**PLANNED UNIT DEVELOPMENT
& SUBDIVISION STAFF REPORT****Date: March 7, 2013****DEVELOPMENT NAME**

Westwood Plaza Subdivision

LOCATION7765 Airport Boulevard
(Southeast corner of Airport Boulevard and Schillinger
Road South, extending to the North side of Thomas Road)**CITY COUNCIL
DISTRICT**

CONTEMPLATED USEPlanned Unit Development Approval to allow multiple
buildings on a single building site, with shared access between multiple building sites, and
Subdivision approval to create 5 lots.**TIME SCHEDULE
FOR DEVELOPMENT**

SITE PLAN

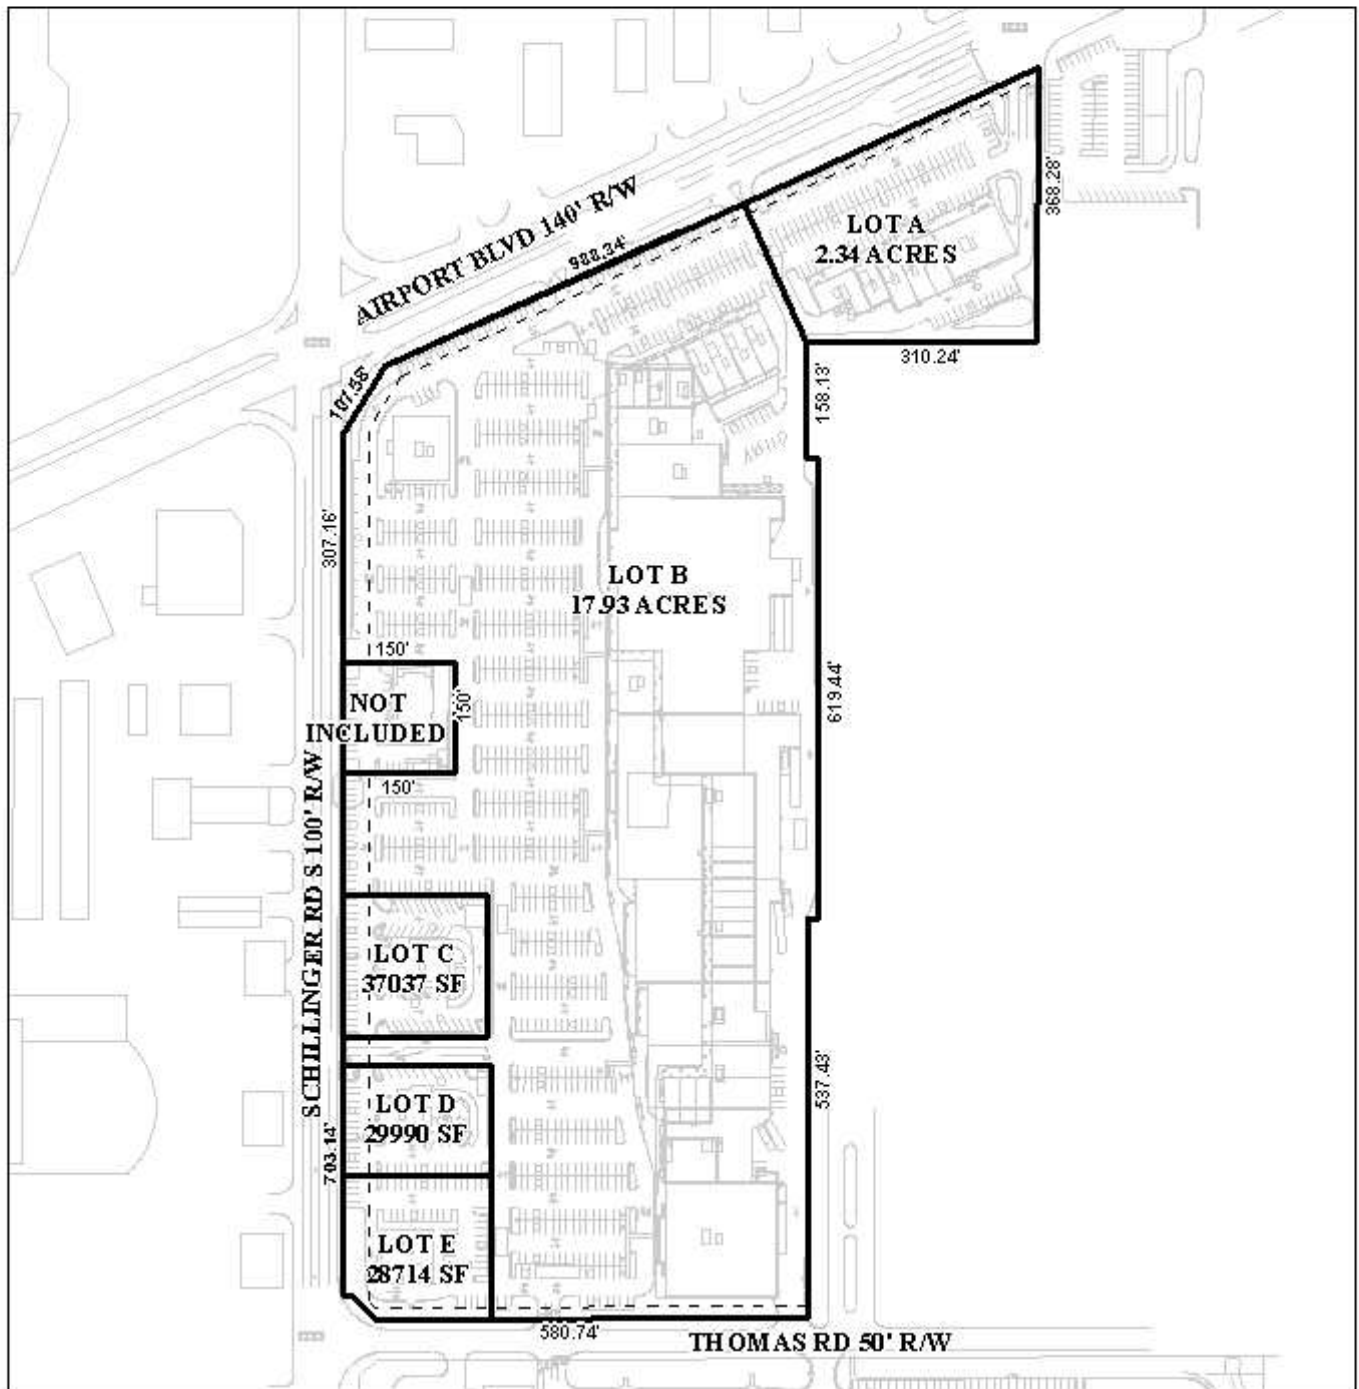
The site plan and Subdivision plat, but not the tree/landscape plan, depict the dedication of 10-feet of right-of-way along Schillinger Road between Airport Boulevard and the Wendy's lot. The applicant states that dedication of right-of-way along other portions of Schillinger Road, as recommended by staff, is not possible due to "*the parking requirements of national retailers.*" In lieu of additional dedication, the site plan reflects a 35-foot setback from Schillinger Road.

Staff maintains that dedication of 10-feet along all of the proposed Lot B and Lot E frontage along Schillinger Road should be required. For proposed Lots C and D, which are developed with fast food restaurants near the road, staff recommends the additional building setback of 35 feet in lieu of dedication. The justification for dedication or additional setback is that traffic volumes will only continue to increase along this segment of Schillinger Road, and due to the scope of redevelopment proposed for this site, it would appear that now is the best time to prepare for future widening projects.

The revised tree / landscape plan does not reflect the proposed right-of-way dedication depicted on the site plan and Subdivision plat. Furthermore, there is a discrepancy in the number of trees that are proposed: the tree/landscape plan quantities chart lists a total of 216 trees, staff counted 214 trees, and the applicant's expanded and revised narrative letter states a total of 186 trees (see table below). It should be pointed out, however, that the applicant proposes to provide 32 frontage trees that will be larger 6-inch caliper specimens, exceeding the 3-inch caliper minimum required.

No buffer is depicted on the revised site plan or the tree/landscape plan where the site abuts the residential district to the East of the site, as required by Section 64-4.D. of the Zoning Ordinance.

- 1) The site plan to does not reflect right-of-way dedication along Schillinger Road, as specified by the Major Street Plan component of the Comprehensive Plan as well as the Subdivision Regulations;
- 2) The site plan does not fully comply with the tree and landscape requirements of Section 64-4.E. of the Zoning Ordinance; and
- 3) A residential protection buffer is not depicted along the East property line, as required by Section 64-4.D. of the Zoning Ordinance.
